RESOLUTION NO. 2022-82

RESOLUTION OF THE VILLAGE BOARD OF THE VILLAGE OF CALEDONIA TO APPROVE 2 WAIVER MODIFICATIONS AND A PROPOSED CONCEPT PRELIMINARY PLAT THAT WILL CREATE 30 SINGLE-FAMILY RESIDENTIAL LOTS FOR THE PARCEL LOCATED AT 6020 ERIE STREET AND THREE PARCELS LOCATED WEST OF 5945 ERIE STREET (NOW WATERS EDGE) SUBMITTED BY JOHN WAHLEN, APPLICANT, VILLAGE OF CALEDONIA, OWNER (PARCEL ID NOS. 104-04-23-16-021-000, 104-04-23-21-016-010, 104-04-23-21-016-000 & 104-04-23-21-021-000)

MEMORANDUM

Re: The Glen At Waters Edge Preliminary Plat – SW ¼ Section 16 & NW ¼ Section 21 Range 23 East Town 4 North Parcel ID's 51-104-04-23-16-021-000, 51-104-04-23-21-016-000, 51-104-04-23-21-016-010, & 51-104-04-23-21-021-000

PRELIMINARY PLAT OF THE GLEN AT WATERS EDGE

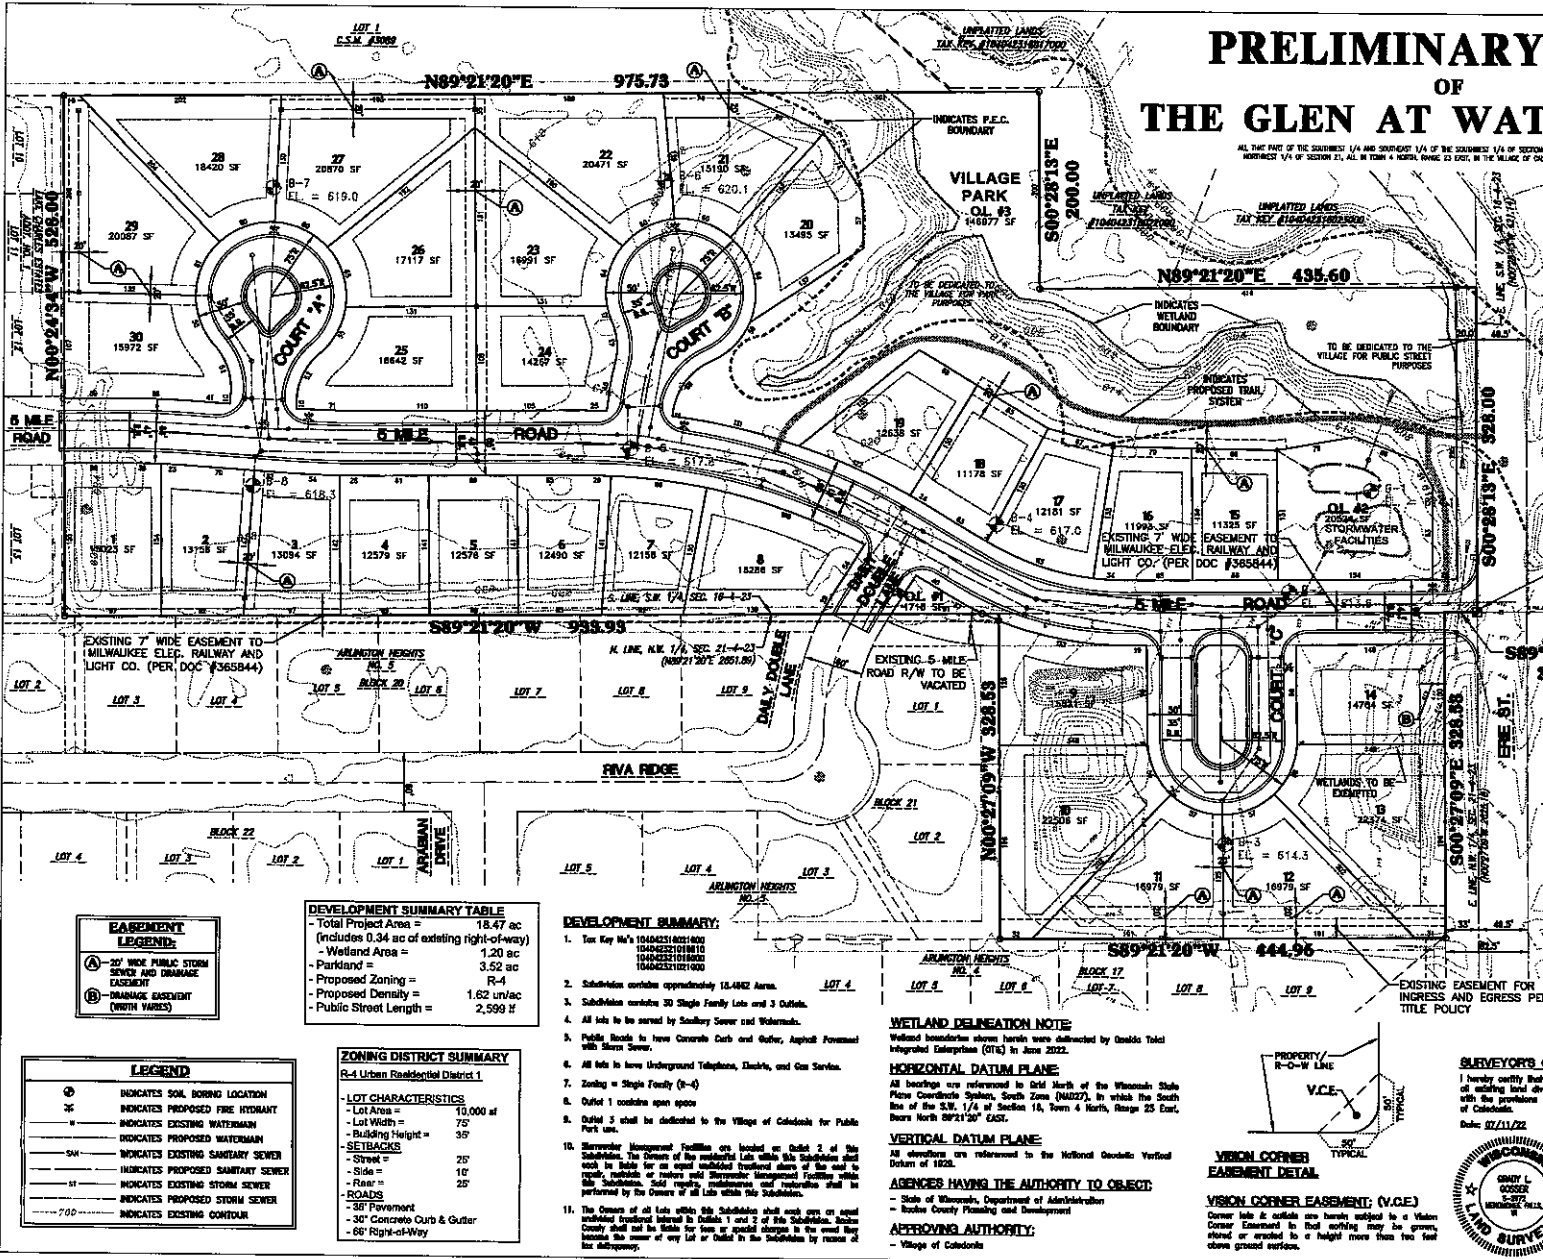
5 Mile Road is considered a principal throughfare. Typically, a principal throughfare would require a 90' Right of Way. With an Urban Arterial Road Cross Section from the Ordinance, a 70' Right of Way would be sufficient. The 70' Right of Way would also match the Right of Way width on 5 Mile Road in Lake Charles Estates (subdivision immediately to the West). A 70' Right of Way for 5 Mile Road should be granted.

The 3 proposed cul de sacs are considered local roads. 66' of Right of Way would be appropriate for the straight sections of the cul de sacs. The proposed cul de sacs have 75' Radii for the Right of Way. The Radii of the cul de sacs shall be 80'.

The Preliminary Plat will need to be revised to update the Right of Way as indicated above.

Access for the parcels shall be limited to 1 access per single family lot. There shall be 50' No Access restrictions placed at the intersection of all corner lots (Lots 8, 9, 14, 24, 25, & 30). There shall be No Access Restrictions placed along 5 Mile Road on the lots with secondary frontage on 5 Mile Road (Lots 9, 14, 24, 25, & 30. Lot 8 shall be allowed access to 5 Mile Road due to insufficient frontage on Daily Double Lane.). There also shall be No Access Restrictions placed along Waters Edge (Lots 13 & 14).

In addition to No Access Restrictions there also will need to be 25' x 25' Vision Triangle Easements placed at the intersections of all corner lots (Lots 8, 9, 14, 24, 25, & 30). The detail provided will need to be adjusted as necessary and the easements will need to be shown on the lots.

The Engineering Department has reviewed the Preliminary Plat and recommend approval of the Preliminary Plat of The Glen At Waters Edge subject to the following conditions:

- The execution of a Pre-Development Agreement and Deposit of \$3,000.00.**
- Approval of Modification Waivers from Ordinance 14-3-4(c)(4)(b)(ii) and Ordinance 14-3-5(b).**
- Approval of the Rezoning Request from R-3 to R-4.**
- Correct the Road name from Erie Street to Waters Edge.**

- **Add Names for Cul De Sacs.**
- **Addition of the Owner of the Parcels. Include name, address, and telephone number.**
- **Addition of all platted Right of Ways within 300' of the Plat (Silent Sunday Court, North Pointe Drive & Waters Edge).**

- **Addition of all public and private easements within 300' of the Plat.**
- **Provide ownership information for lots within 100' of the Plat.**
- **Designate areas of slopes greater than 12%.**

- **Note if there are any Burial, Historical, or Cultural Resources on the property.**
- **A legal description of the parcels.**
- **Provide Density calculations for the Plat.**

- **Primary Environmental Corridor will need to be confirmed by SEWRPC.**
- **Wetland Buffers/Setbacks and uses are shown as necessary. Add Notes describing the maintenance (e.g., No Mow) of the Wetland Buffer. Also add Notes as necessary for what uses can be done in wetland buffers.**

- **Adjust Lot 17 to remove Primary Environmental Corridor from the Lot.**
- **The Right of Way width of 5 Mile Road shall be 70'.**
- **The Right of Way for the local streets shall be 66'. Radii for the cul de sacs shall be 80'.**

- **Adjust the road widths for 5 Mile Road and the 3 cul de sacs to the required widths by the Ordinance. (Urban Arterial Road & Urban Cul de sac)**
- **Addition of a Note for all parcels being limited to 1 access.**

- **50' No Access Restrictions placed on the lots at the intersections (Lots 8, 9, 14, 24, 25, & 30).**
- **No Access Restrictions placed along 5 Mile Road on lots with secondary frontage on 5 Mile Road (Lots 9, 14, 24, 25, & 30. Lot 8 shall be allowed access to 5 Mile Road due to insufficient frontage on Daily Double Lane.).**

- **No Access Restrictions placed on Waters Edge (Lots 13 & 14).**
- **25' x 25' Vision Triangle Easements placed on the lots at the intersections (Lots 8, 9, 14, 24, 25, & 30). Adjustment of the detail for Vision Corner Easement for distance and that there shall be nothing grown, stored, or erected to a height more than 6" above the ground surface.**

- **Addition of a note for Outlot 2 being used for Storm Water purposes and being a Storm Water Easement. In addition, this will require a separate Storm Water Easement to be recorded to cover liability, maintenance, and a maintenance schedule.**

- **The granting of a 12' Drainage & Utility Easement along the exterior boundary of the subdivision. This will not be required along Outlot 1 or Outlot 3.**

- **Will need to add Utility Easements to the Plat when Utility layouts have been completed.**
- **Add Note on the Plat for restricting trees, plantings, buildings, berms, fences, etc. in easement areas and Right of Ways.**

- **Add Note on the Plat that Driveways shall not have a centerline slope steeper than 6%.**
- **Add Note on the Plat that “Lots have been filled greater than 3 feet and may require additional courses in the foundations to reach suitable soil. Will need to provide a soil compaction certification for the areas of greater than 3 feet of fill.”**
